From: Matt Breuer <Matthew.Breuer@WasteConnections.com>
Sent: Saturday, February 14, 2026 6:38 PM
To: gvergara@aqmd.gov
Cc: Kevin Green; Sarah Phillips; Dylan Smith; Christina Ojeda
Subject: Notice to Comply - Rule 1150.1 C58344
Attachments: E58344_signed.pdf; SCAQMD Inspection 20260204 - Field Response and Corrective Actions Report.pdf; SCS Field Response to SCAQMD February 4, 2026 NTC

NOTICE TO COMPLY

Facility Name: Chiquita Canyon Landfill		Facility ID#: 119219	Sector: VB
Location Address: 29201 Henry Mayo Dr.		City: Castaic	Zip: 91384
Mailing Address: 29201 Henry Mayo Dr.		City: Castaic	Zip: 91384

SCS Field Response to SCAQMD February 4, 2026 NTC

Well CV-24037

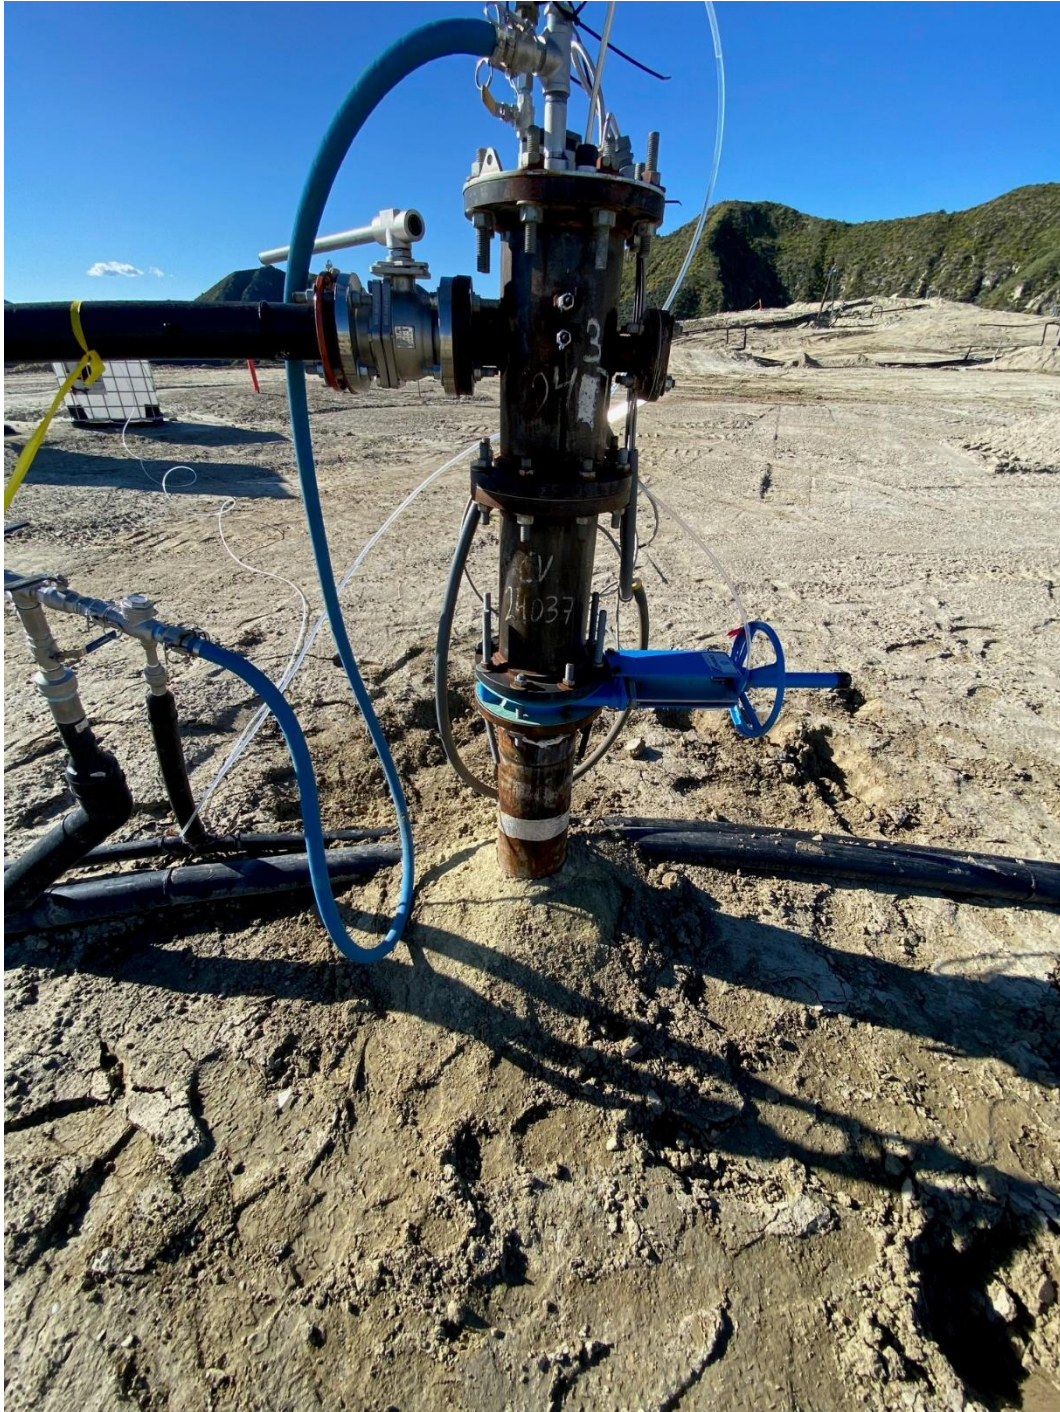
1. Well CV-24037
2. Zeeco blower housing
3. Zeeco Sump
4. H2S Vessel 2 Inlet
5. H2S Vessel 4 Inlet

- At the H2S Inlet Piping for Vessels 1, 2, 3 and 4:
 - Fresh soil was brought to each individual inlet vessel and compacted using both a hand compactor and a backhoe bucket to ensure adequate sealing and minimize emissions. (Note: work was conducted at Vessels 1 and 3 as preventative maintenance).
- At Well CV-24037:
 - Fresh soil was placed around the casing of the well and compacted using a backhoe bucket and hand compactor. This action was intended to improve containment and prevent further emissions.
